Fuel Tank Fill System – Non or Slow Filling

Bulletin Type:	SRP
Bulletin #(s):	19-021
Job Code(s):	**
Flat Rate(s):	**
<i>** If affected unit has warranty remaining, submit your claim following the normal process.</i>

Publication Date:	January 2021
Make(s):	Jayco Towable
Model(s):	Seismic FW Talon FW
Model Year(s):	2017-2019

Instructions:

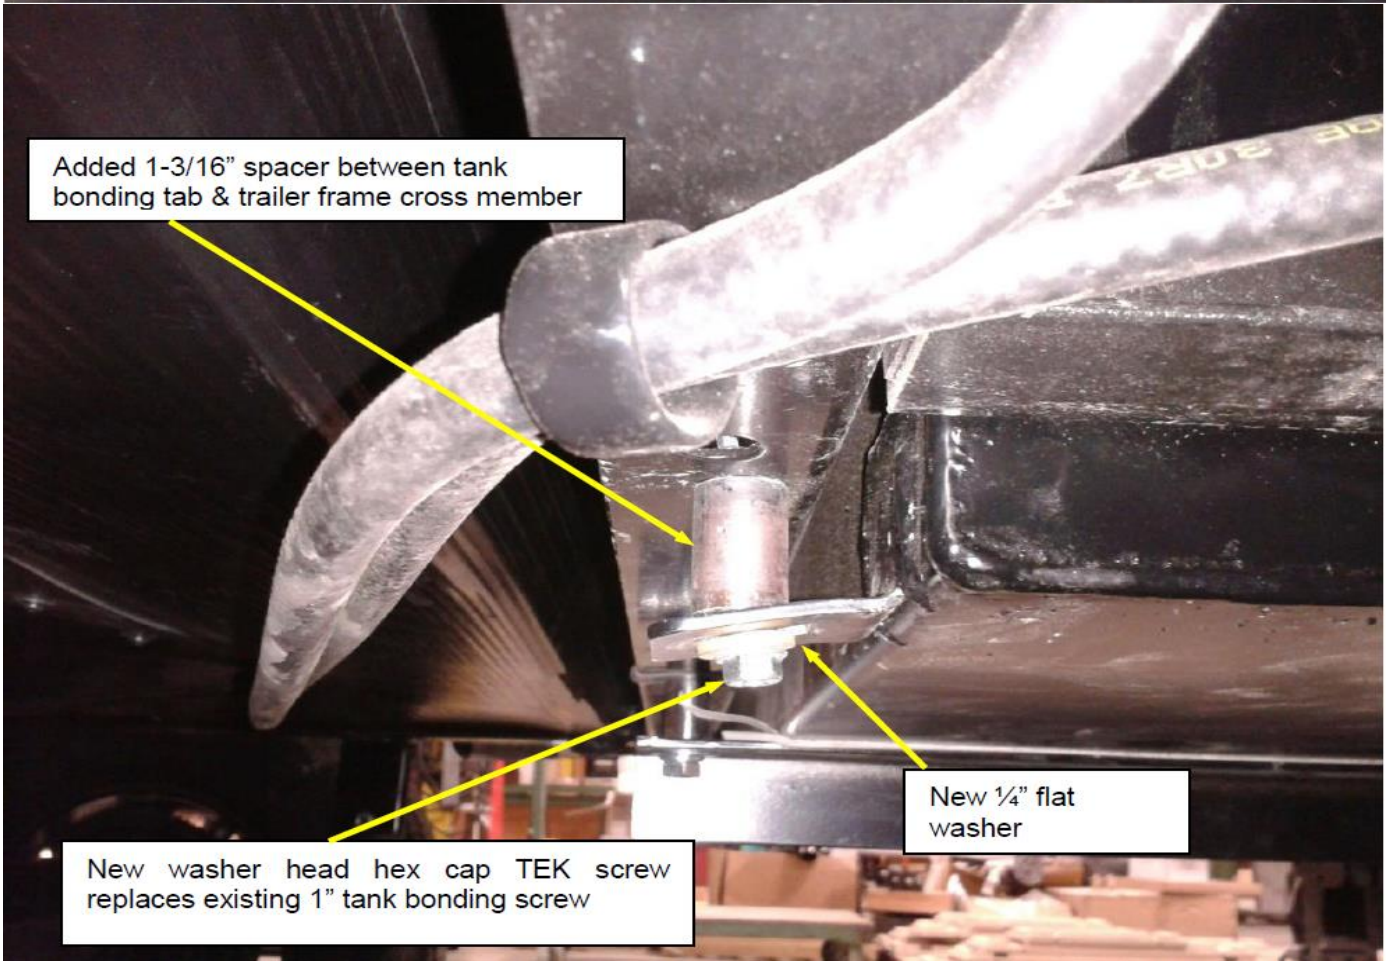
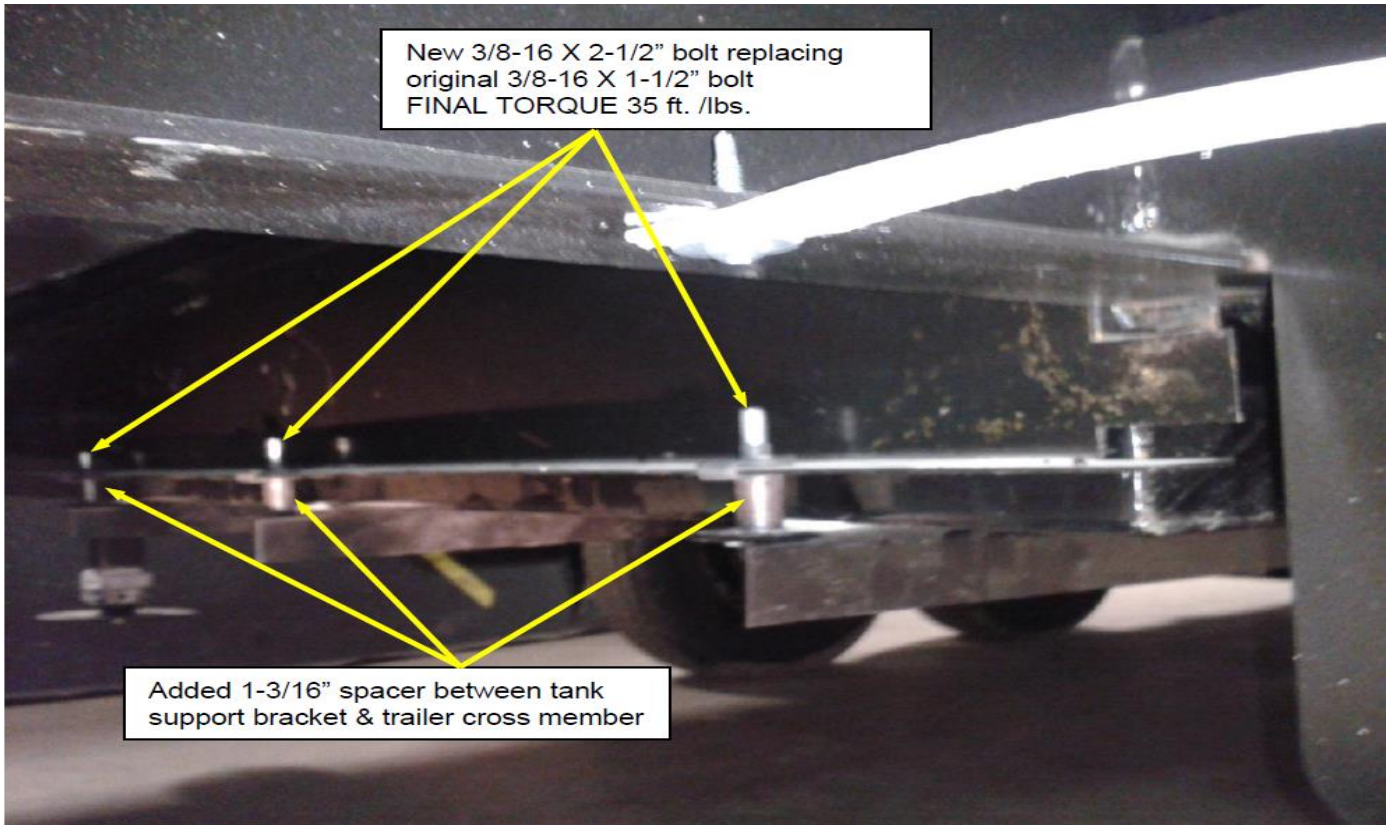
NOTE: The fuel tanks may be lowered WITHOUT complete removal and reinstallation of either tank.

1. Begin with the **Front tank**.
 - a. Remove the 1/4" X 1" washer head hex cap TEK screw at the tank-bonding tab.
 - b. Loosen each of the bolts at the tank support brackets across the bottom of the tank – DO NOT REMOVE the bolts.

- i. This will allow the tank to lower resting on the support brackets.
 - c. ONE BY ONE remove each bolt at the tank support brackets across the bottom of the tank place a spacer between the frame cross member and the tank support bracket.

- i. Using the new 2-1/2" bolt, flat washer and lock washer insert through the bracket and spacer into the tinnerman nut on the cross member.
 1. Do not fully tighten the new bolt.

2. Run the bolt only far enough for about (2-3) threads past the end of the tinnerman nut on the cross member.
 - ii. Repeat for each end of each bracket until all bolts, flat washers, and lock washers have been replaced.

1. The tank should be lower by more than one (1) inch.
 - d. Reach across the top of the tanks place the 1 X 2 X 27.5" steel tube (laid flat) on the top of the tank.

- i. Ensure the tube is on the tank top and under two of the three steel straps of the trailer frame.
 - ii. Work the tube to be positioned cross -way to get part of the tube under the flange of the trailer cross members at both sides of the tank.

- iii. Keep clear of wires and the sending unit on top of the tank.
 - e. With the tube in place at the top of the tank and all new bolts, washers, and bottom spacers in place tighten all bolts at the bottom brackets.

- i. Final torque 35 ft. /lbs.
2. **Back tank**
 - a. Repeat the steps followed in 1.a-c for the front tank.
 - b. Use the 1 X 2 X 25" steel tube (laid flat) on the top of the tank. See step d. i.-iii for the front tank.

- c. With the tube in place at the top of the tank and all new bolts, washers, and bottom spacers in place tighten all bolts at the bottom brackets.
 - i. Final torque 35 ft. /lbs.
- 3. The slope of the fuel fill hoses should now be at least 1 to 1-1/4-inch lower at the tank inlet than at the fill neck outlet. This will allow filling at full nozzle delivery pressure.

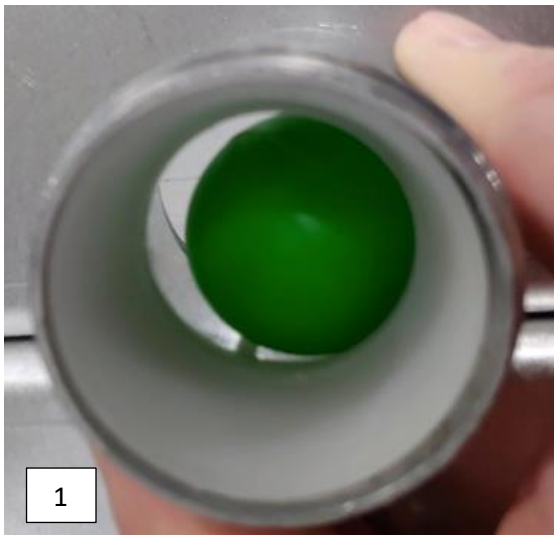
The first 2 photos depict what you would see on a normal tank from inside the tank and also the front of the tank. This is what is considered a good/normal install which will allow fuel to flow with no issues. The check ball should move freely with the confines of the three prongs.

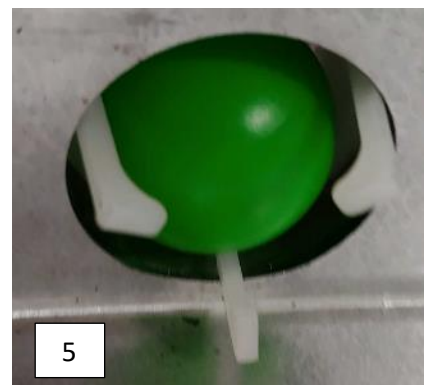
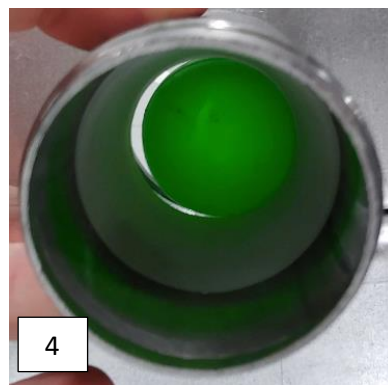
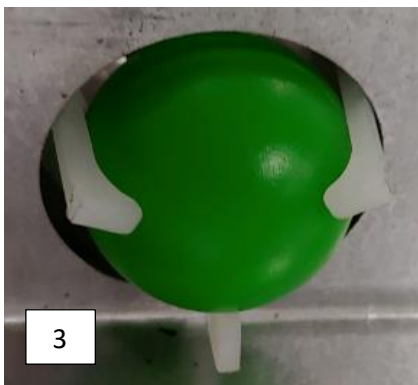
Photos 3-5 show the ball check valve fingers have become compressed and pushed or inserted into the tank opening which is restricting the ball movement and causing the slow fill. The photos depict the worst case scenario, showing the maximum amount the ball valve can be pushed into the tank.

1. Ball check valve retainer is deformed, restricting the ball valve. Replace ball check valve.
2. Ball check valve assembly is incorrectly located in the fill neck. Reset ball check valve in correct location.

Photo 6-7 are of the ball check valve assembly. Jayco part # 0322725.

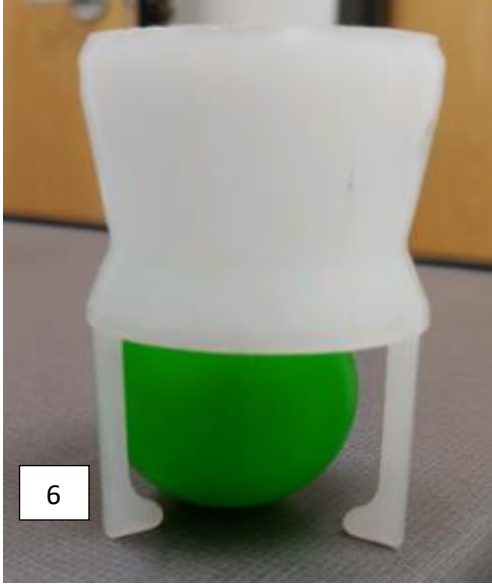
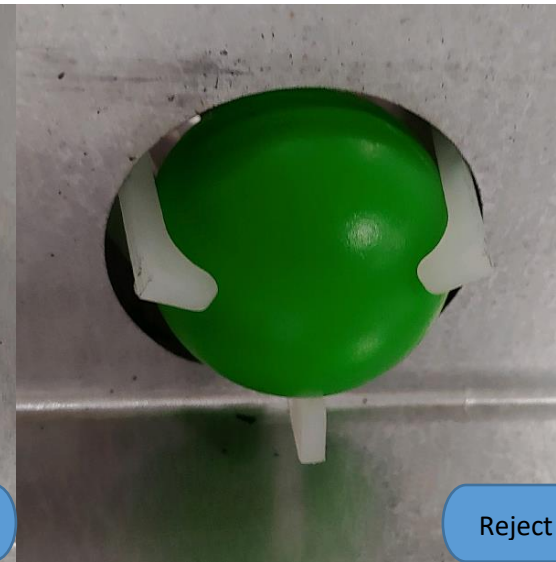
The ball should move freely with the confines of the three prongs.
